Livesay Park

Town of Fairhaven ADA Transition Plan

August 2024

Figure 1 shows a stable, firm and slip-resistant surface adjacent to a bench positioned to allow a person in a wheeled mobility device and a person sitting on the bench to have their shoulders aligned:

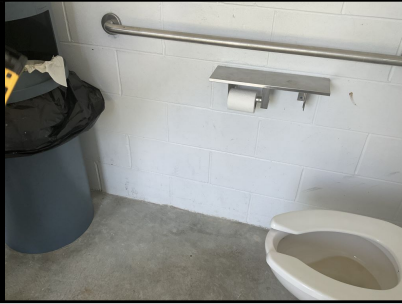
- Recommend providing a 36” min. by 48” min. stable, firm and slip-resistant surface adjacent to at least one of the existing benches in each unique program area in the park in a manner that is substantially similar to what is shown in Figure 1.
